City of Keene Planning Board

AGENDA – AMENDED

Monday, February 27, 2023

SPR-01-23 – Site Plan Review – Granite State Car Wash – 364 West Street & 12 Pearl Street

Fig 2: Front elevation (Pearl Street façade).

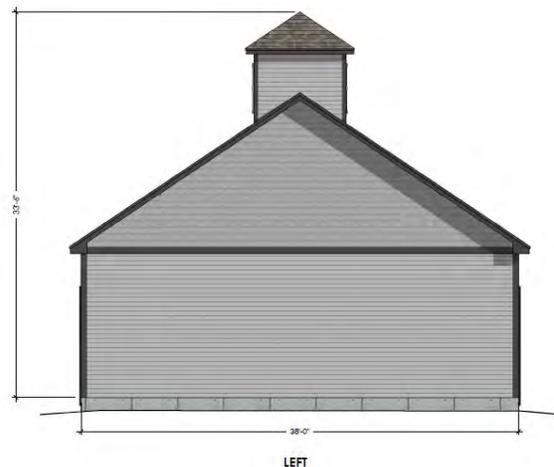
The applicant states in their narrative that the proposed carwash will be a small, 2,000 sq. ft. single story building with a pitched roof. The eastern and western facade of the building will contain two overhead doors providing access to the wash tunnels. A single passage door will provide access to the small office and mechanical room. The building walls will be made of a Nuform polymer-based block material that is waterproof. The building will be 14 ft. from the top of the foundation to the peak of the roof.

The color will be light gray. The roof will be an 8:12 pitch with asphalt shingles, also in gray. The doors and trim will be dark gray in color. A small cupola will be placed on the roof to give the building a traditional New England design that the applicant feels is appropriate for the area. The Planning Board will need to determine if this standard has been met.

SHEET C-1

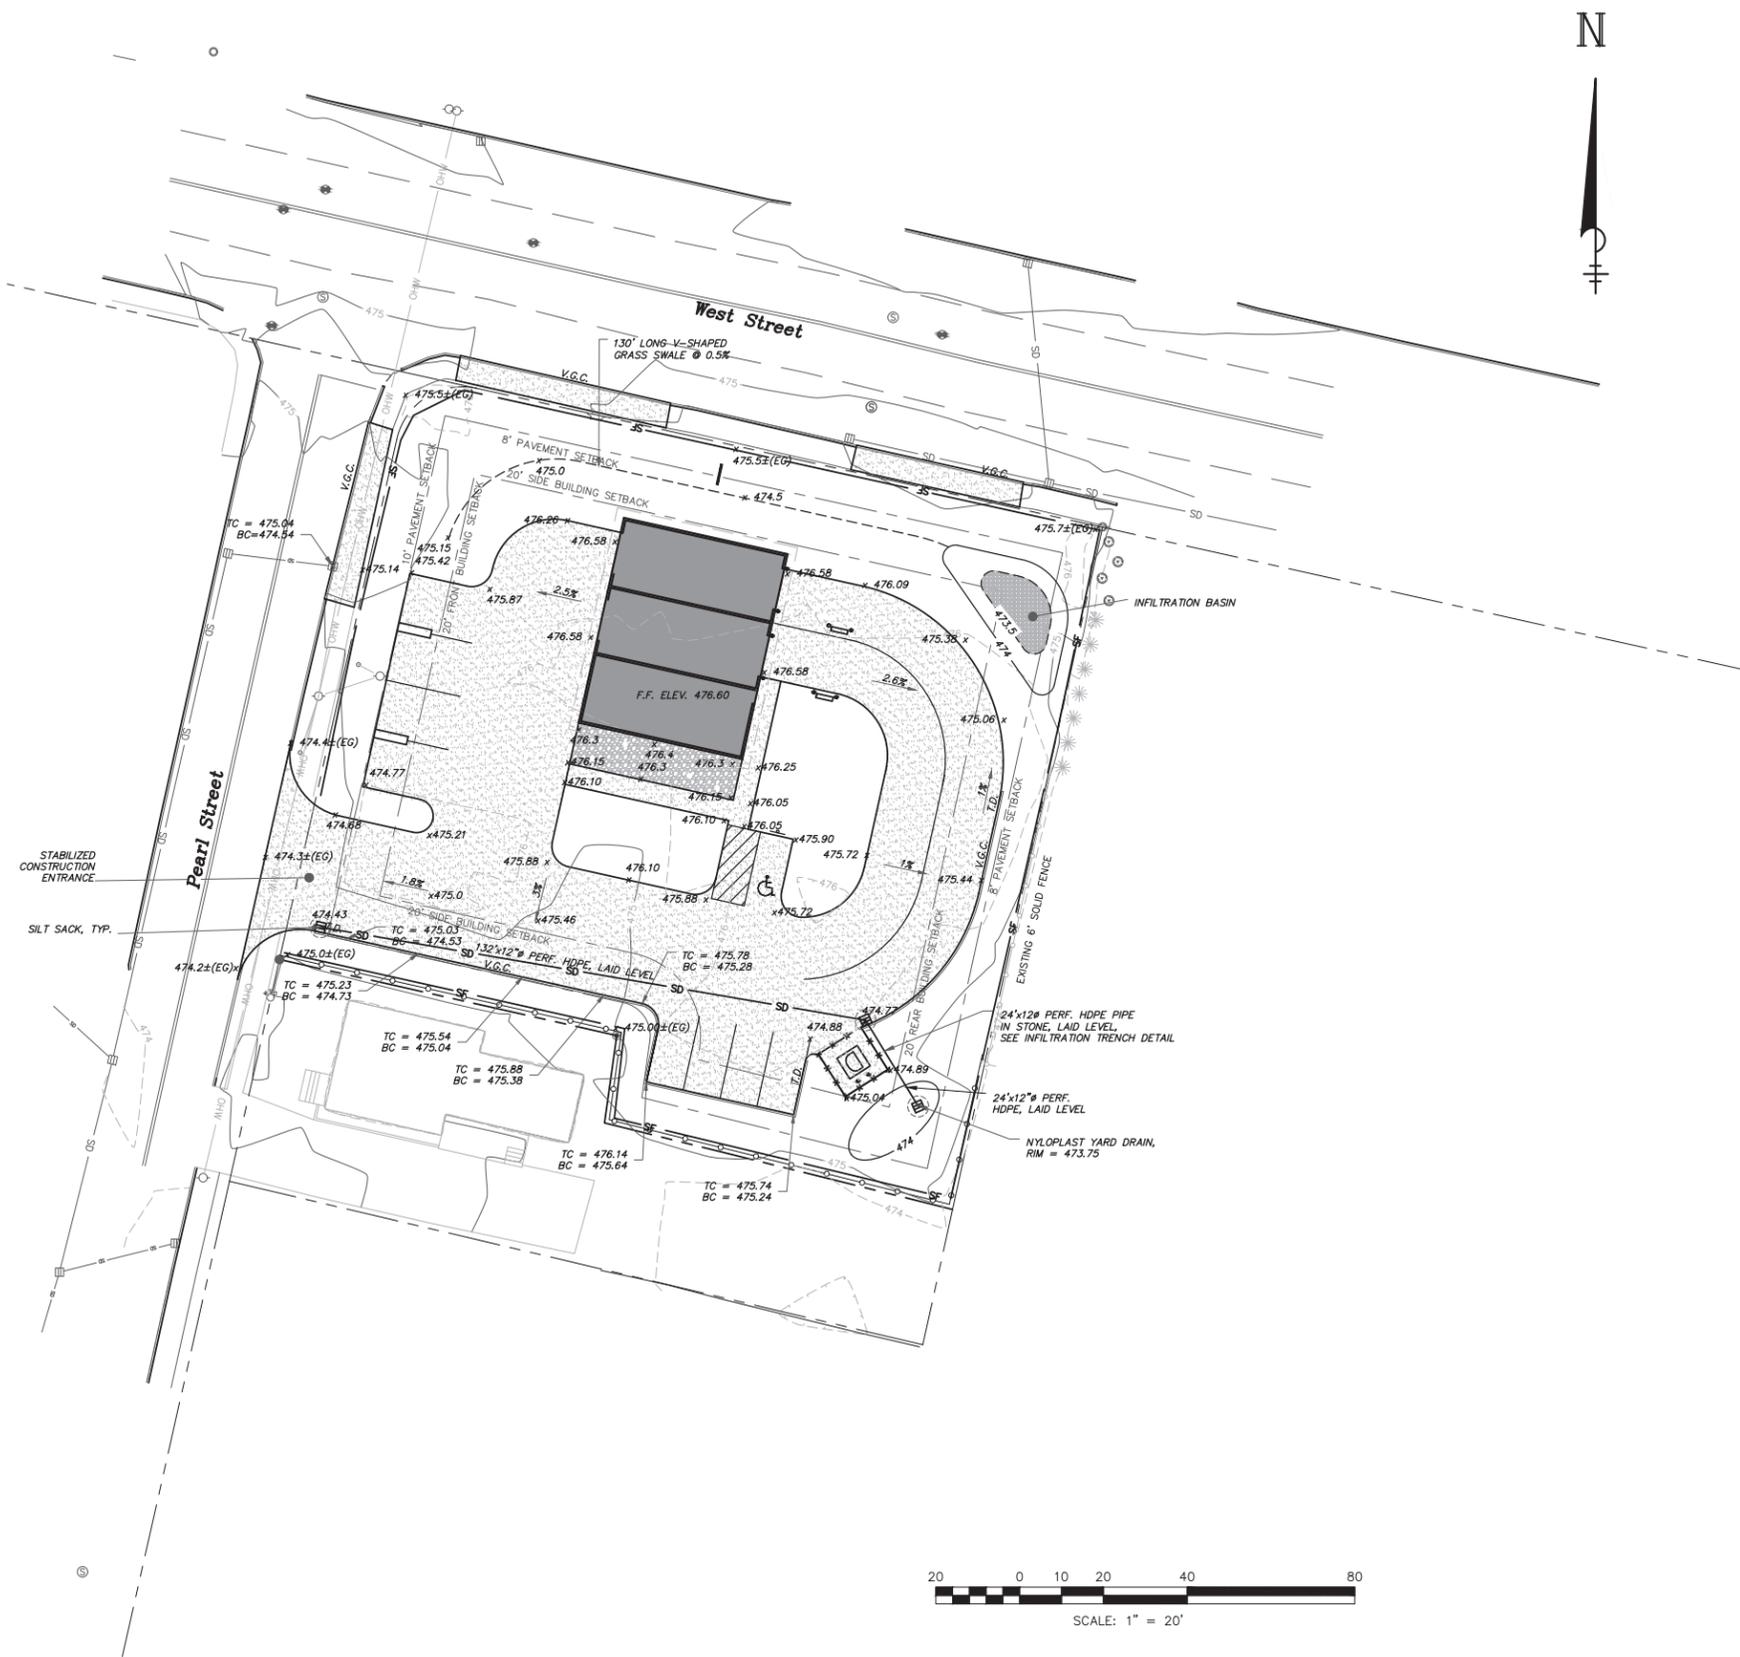
- 20.4 **Snow Storage & Removal:** The Site Plan, sheet C-1 shows snow storage areas along the eastern property line and to the north the of the proposed drive-thru lanes. The applicant states in their narrative that there is room for snow storage along the perimeter of the paved area. Excess snow will be removed the site after each snowstorm as needed. It appears that this standard has been met.

- 20.6 **Screening:** The Site Plan, sheet C-1 shows a 6 ft. solid wood fence to be proposed along the southern and eastern property lines to screen the adjacent residential uses. Additionally, Rhododendron and Arborvitaes are proposed to be installed along the Pearl Street and West Street frontage to screen the parking and drive-thru facilities from the public right-of-way. The proposed dumpster enclosure will be a 6 ft. solid wood fence.

The applicant has submitted a waiver request to provide relief from Section 20.6.2.B.1 of the Land Development Code, which states, "*Drive-through windows and lanes shall not be located along the building frontage or along a building facade with a primary entrance.*" The applicant states in their waiver request that the proposed site design is required in order to accommodate the decision to abandon the West Street curb cuts and force the building orientation to face Pearl Street.

SHEET LA-1

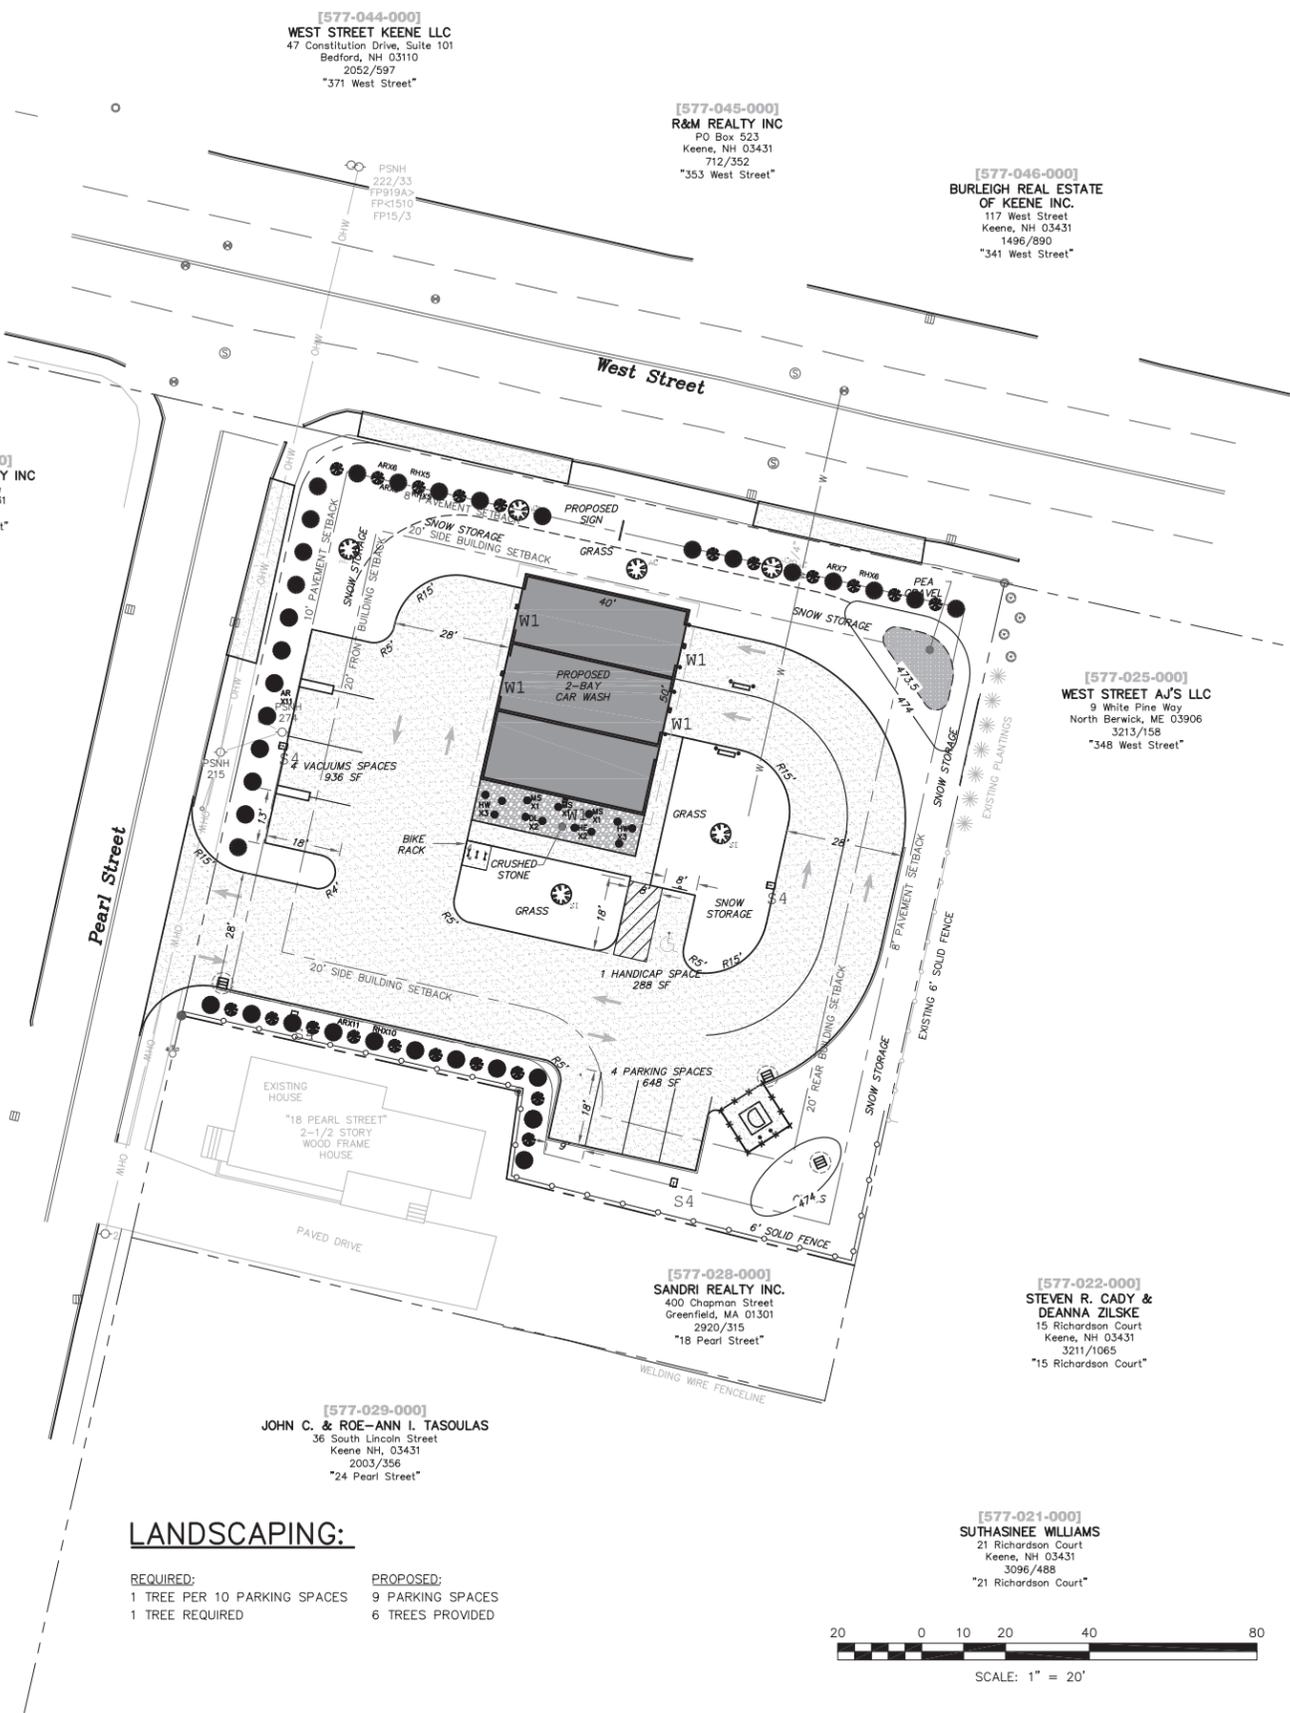
- 20.5 **Landscaping:** The Landscaping Plan, sheet LA-1 shows a selection of perennials, evergreens, and shrubs to be installed on the site. Most of the landscaping will serve as screening from the public right-of-way. An internal landscaping area is proposed along the southern façade of the building. This area will include Blue Rug Juniper, Happy Rose Daylily, and Heuchera. Rhododendron and Arborvitaes will be used for screening along the Pearl Street and West Street frontages. The proposed landscaping also includes the installation of 6 ornamental trees, 4 red leaf maples and two snowdrift crab apple trees. No invasive species are proposed. It appears that this standard has been met.

2. **Screening of Drive-Thru Lanes** – We are adding additional plantings along Pearl Street and West Street to better screen the drive-thru lanes. See revised Landscape Plan.

SHEET LT-1

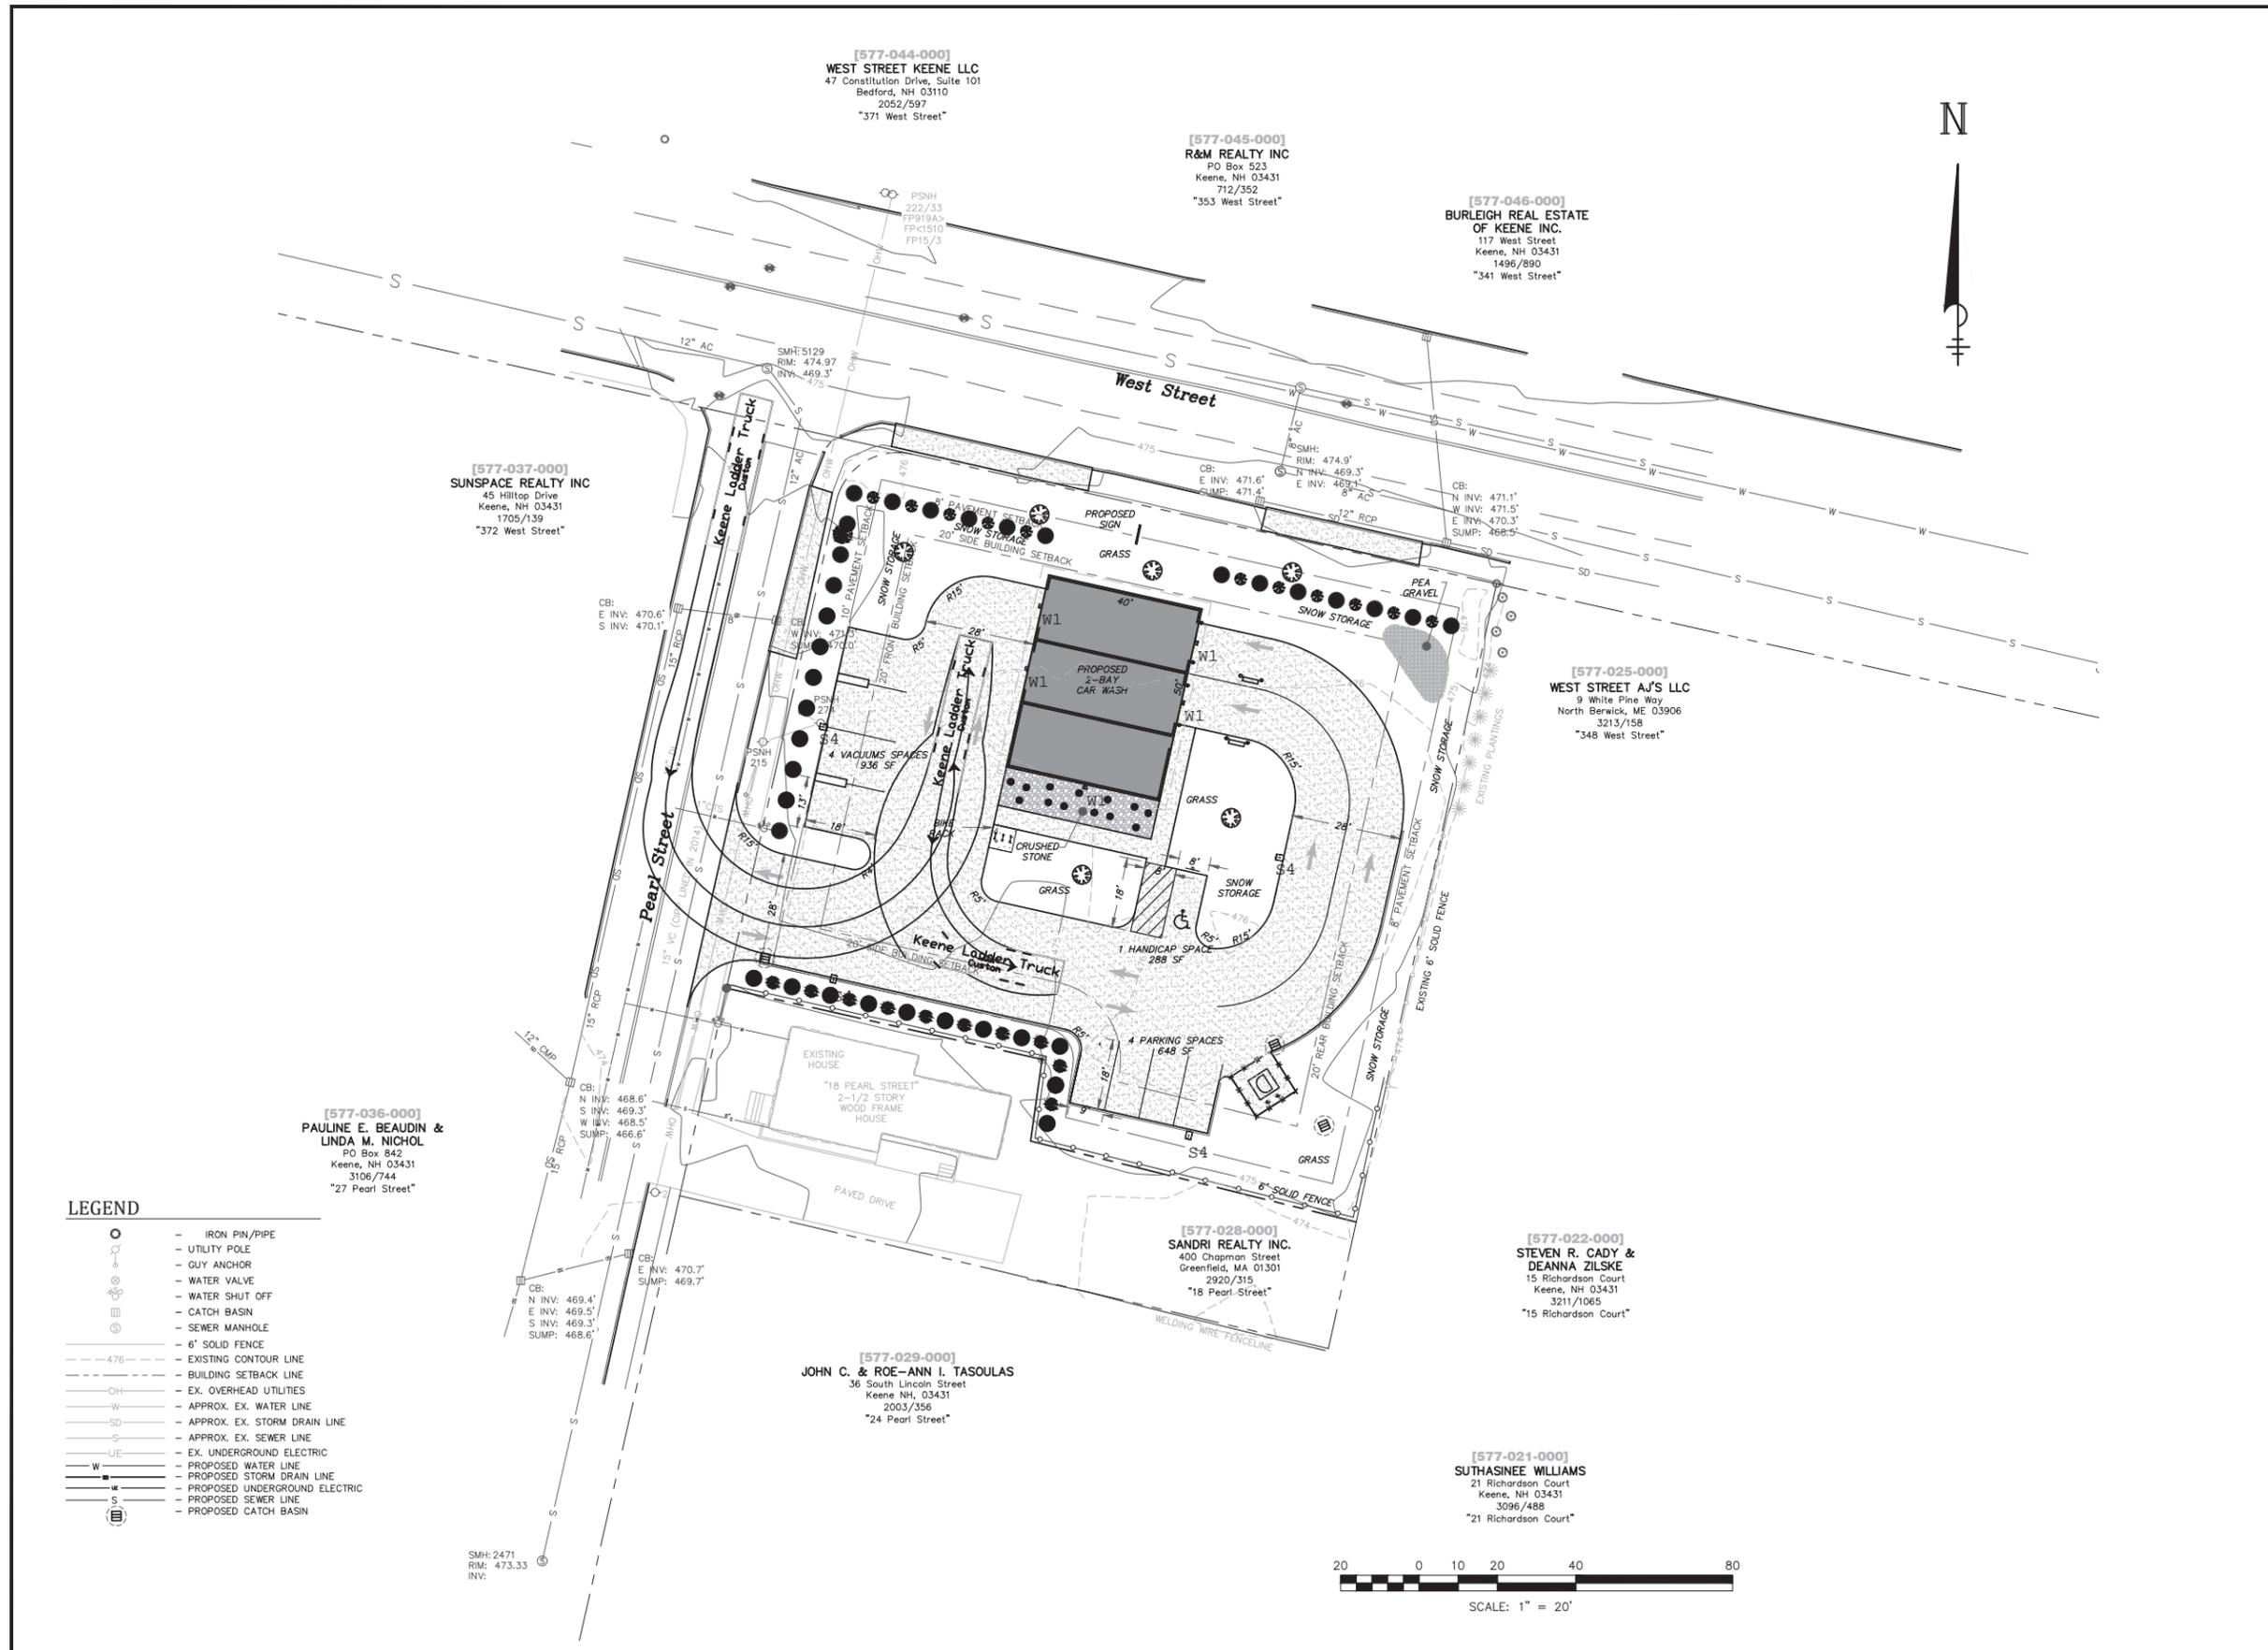
- 20.7 Lighting: The Lighting Plan, sheet LT-1 shows 4 pole-mounted lights in the parking and drive-thru area and 5 wall-mounted lights on the proposed building. The pole lights will be full cutoff LED lights mounted 15 ft. from grade. The wall-mounted lights will be full cutoff LED lights mounted 10 ft. from grade. The average light levels will be 1.32 footcandles at the vacuum stations and 1.12 at the parking spaces. The uniformity ratios are 1.89:1 and 2.24:1 where the standard requires the ratios to not exceed 5:1.

The applicant has submitted a waiver request to provide relief from Section 20.7.3.F.1.c of the Land Development Code, which states, “For 24-hour businesses, lighting levels shall be reduced by a minimum of 50% between the hours of 10:00 pm and 6:00 am.” The applicant states in their waiver request that reducing the light levels below 1 footcandle would create a potentially hazardous condition as the carwash will operate 24-hours and they expect customers after 10 PM.
